## DESIGN REVIEW BOARD

DRB2016-09

Design Review for a Marriott Hotel as Phase I of West Bank Landing

#### WEST BANK LANDING-PHASE I: MARRIOTT SPRINGHILL SUITES-3RD ST NW

2.8
							1.2
							1.5 1.6
					n n		
							1.e 1.7
							1.7 1.7
							1.7 1.7 1.6
	СІТГ			l			
	SILE SCALE: 1"	<u>PHOTOMETR</u>	IUS PLAN

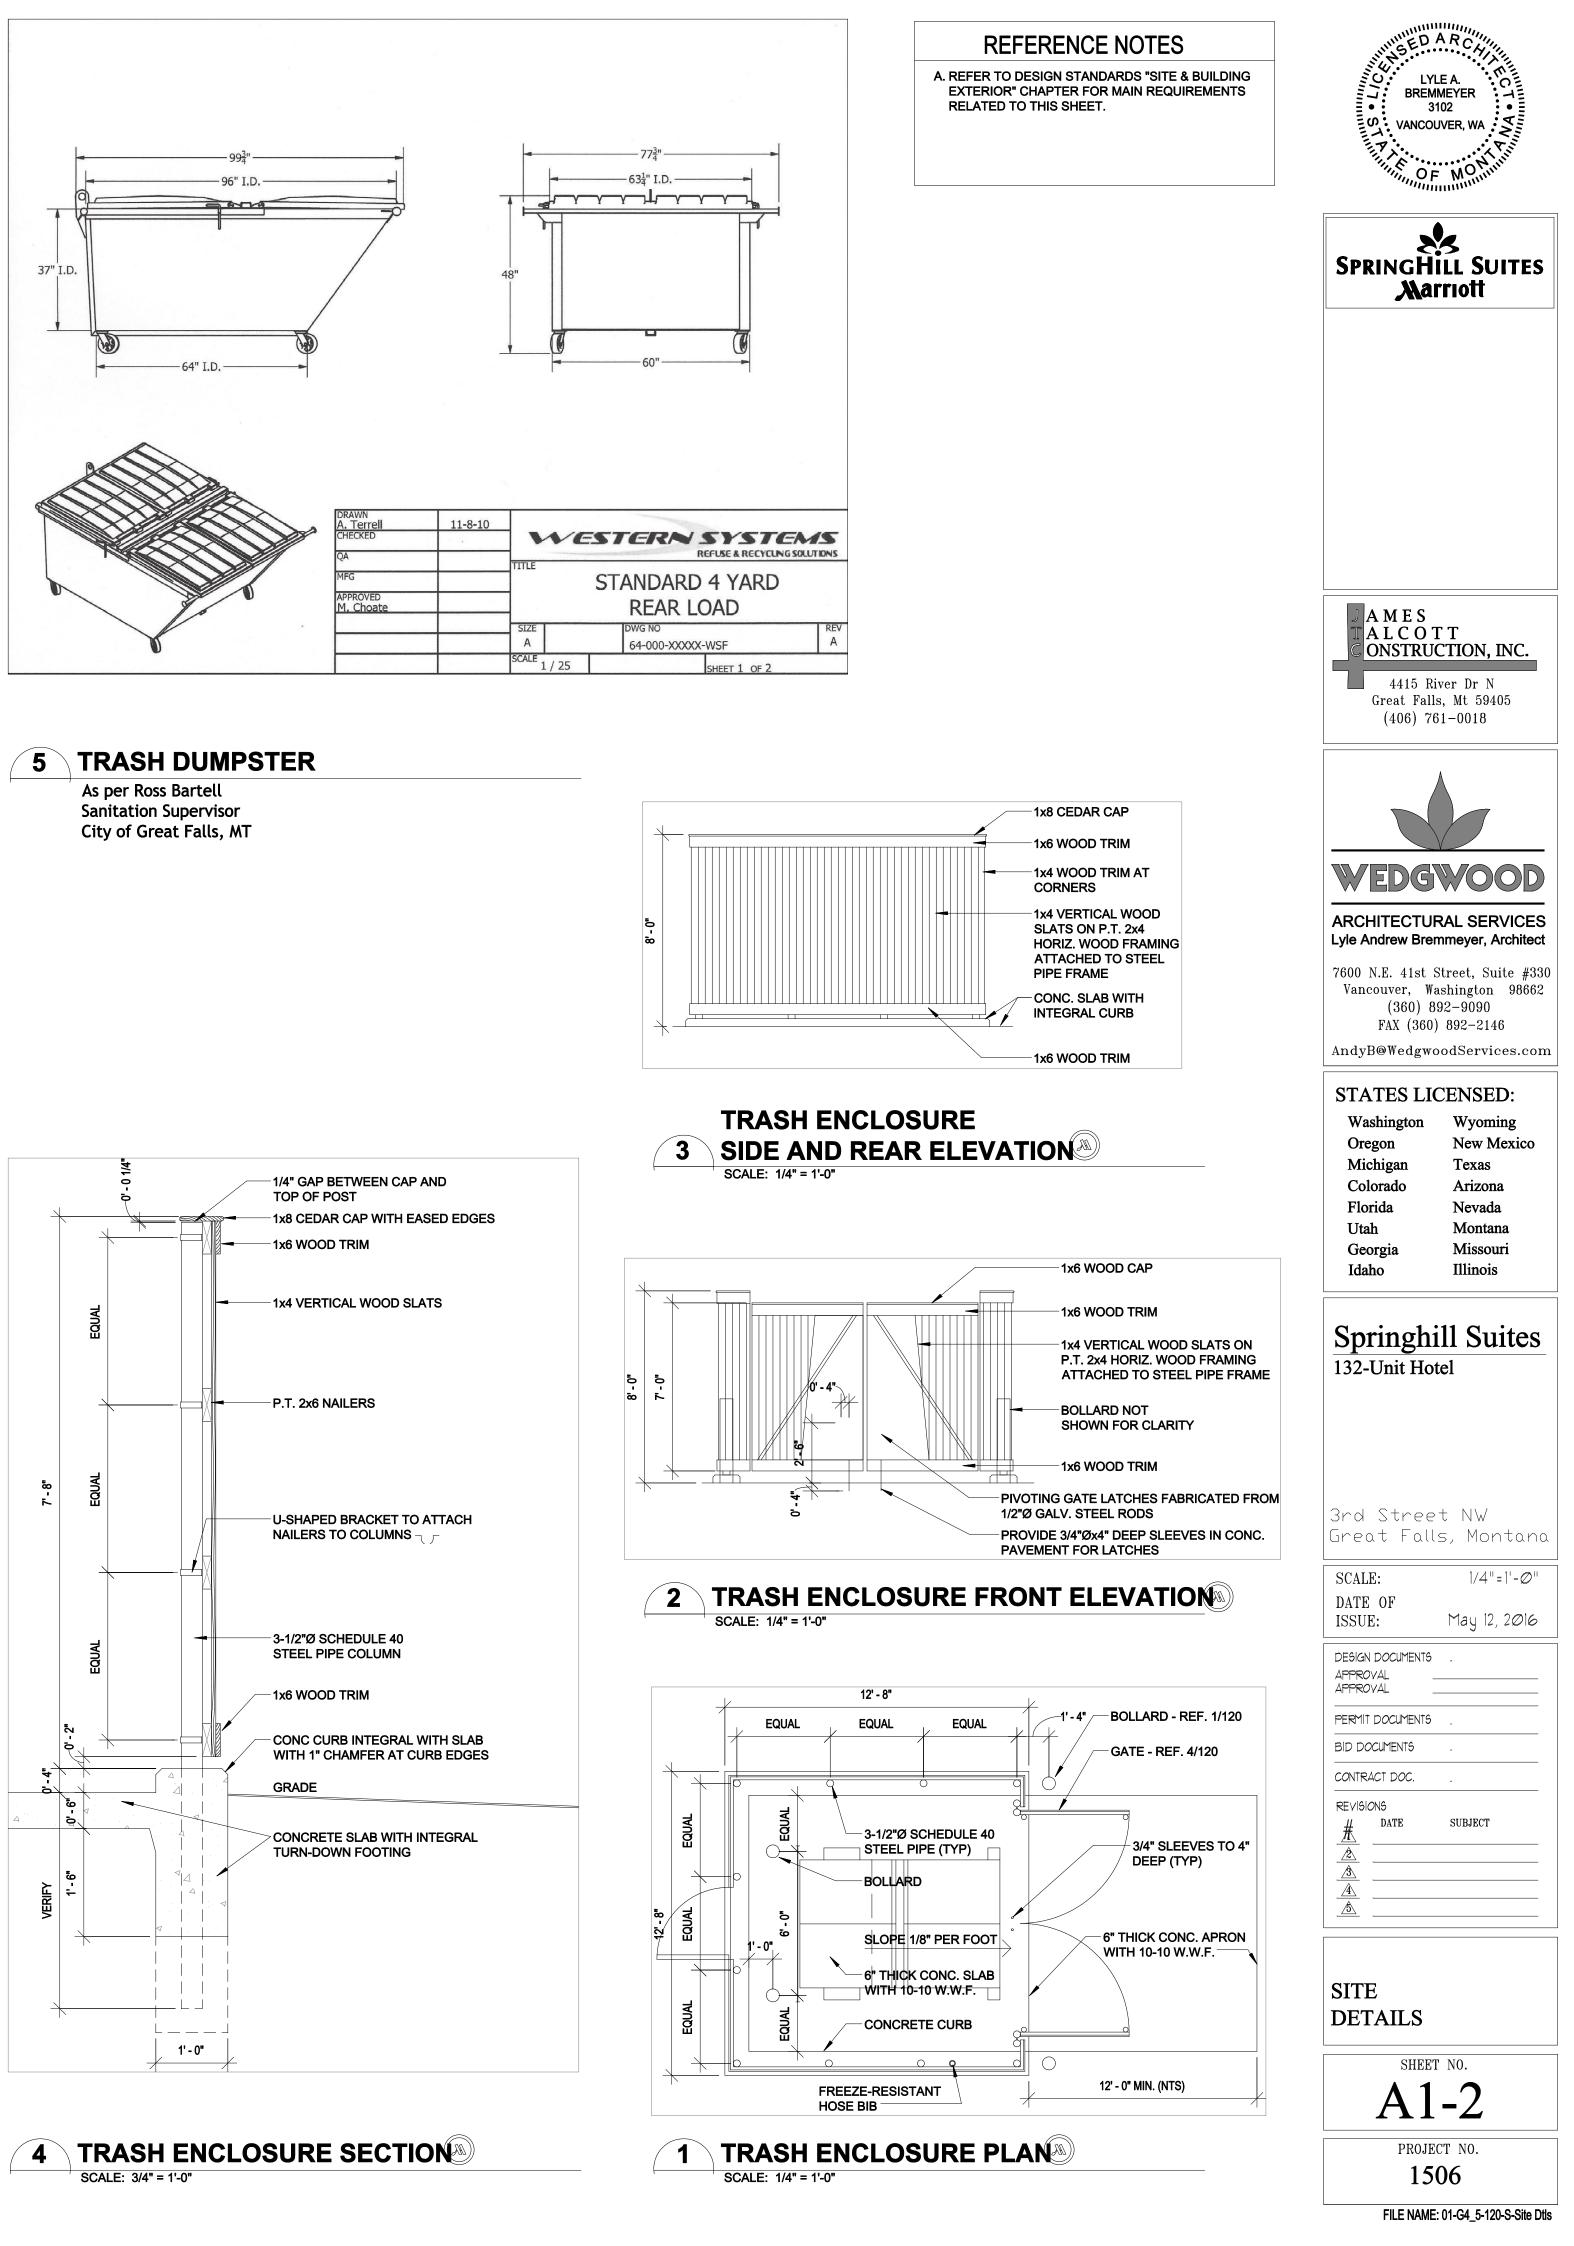
The applicant has provided an outdoor lighting plan which requires minor modification in order to meet the intent of the OCCGF. The foot candles along the east property line shall be adjusted to meet the requirements of the OCCGF. The foot candles at the property line shall not exceed 1.0 foot candles when a commercial use abuts another commercial use as per §17.40.050A. The applicant will continue to work with Staff to bring the lighting plan into compliance with Chapter 40.

- D. The applicant shall revise the outdoor lighting plan to meet the requirements of Chapter 40 as well as the recommendations of Staff.
- E. The applicant shall continue to work with staff to revise the landscape plan to finalize counts based on the Design Waiver and plant species.
- F. The applicant shall terminate each row of parking with a landscape island and turn around areas as per §17.44.3.030.
- 2. Chairman calls for a second, discussion, inquiries from the public, and calls the vote.
- CC Dave Dobbs, City Engineering
  Patty Cadwell, Neighborhood Council Coordinator
  Todd Seymanski, City Forester
  Aaron Perry, James Talcott Construction, representative, <u>aperry@jtc-mt.com</u>
  Spencer Woith, Woith Engineering Inc., representative, <u>spencer@woitheng.com</u>
  Timothy Peterson, LPW Architecture, representative, <u>timothyp@lpwarchitecture.com</u>
